MDI Requirements - MPO with Flat Interface (In support of comment #1-33)

IEEE P802.3db TF Ad Hoc meeting, 04/14/2022

Existing MPO-12 Deployment

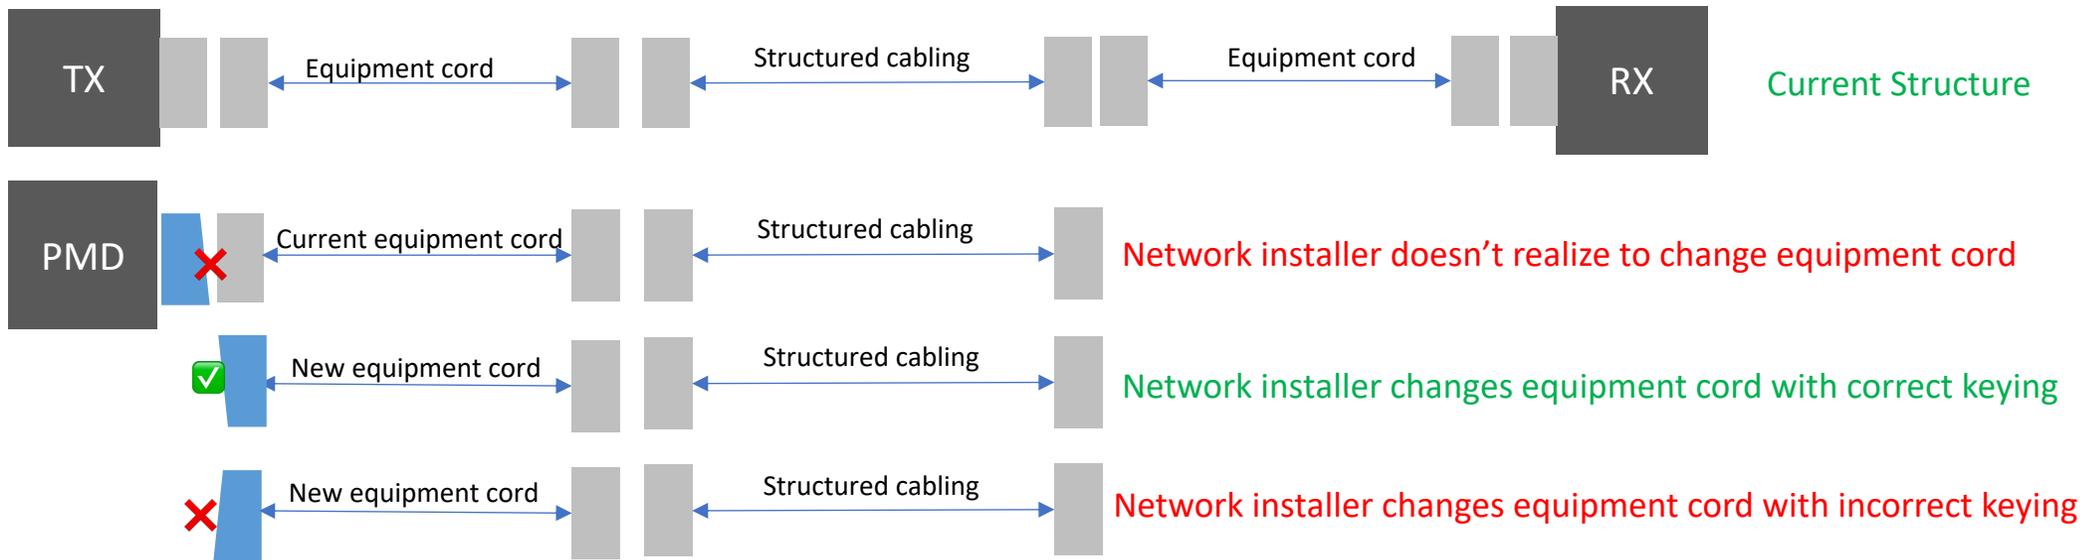
- Enterprise networks are dominated by MMF installation
- 802.3db specifications of 100 Gb/s, 200 Gb/s and 400 Gb/s are expected to be deployed in Enterprise networks
- Cisco estimates that they have sold MPO-12 based MMF module products to more than 7000 customers
- More than 20M¹ modules have already been deployed in networks with flat MPO-12 MMF connectors.
- If P802.3db specification remains with the MDI as APC for MPO-12 connectors this requires cable plant equipment cord replacement and creates compatibility issue with Structured Cabling.

Deployment Risks

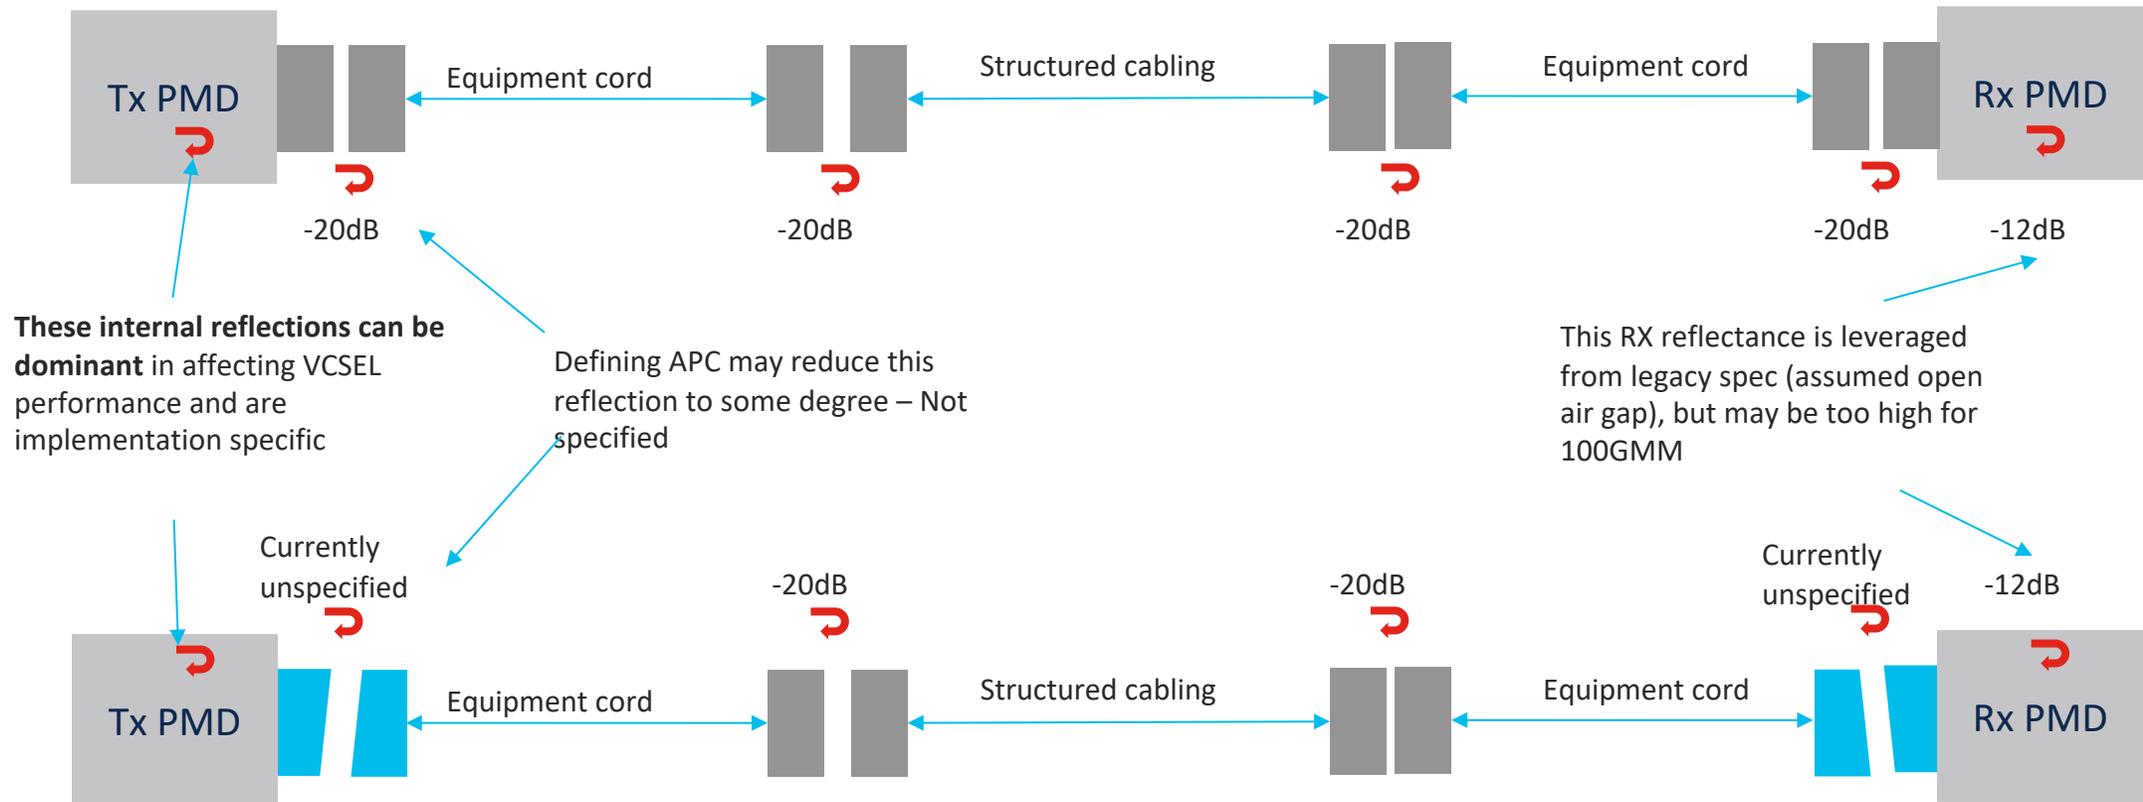
- Additional cost of replacing equipment cords
- Confusion around needing specific equipment cords for specific PMDs
- Incorrect mismatch of PC and APC results in out of spec fiber plant (air gap). Unclear if damage risk exists or not
- Risk of large product returns expected to fiber installer or module manufacturer
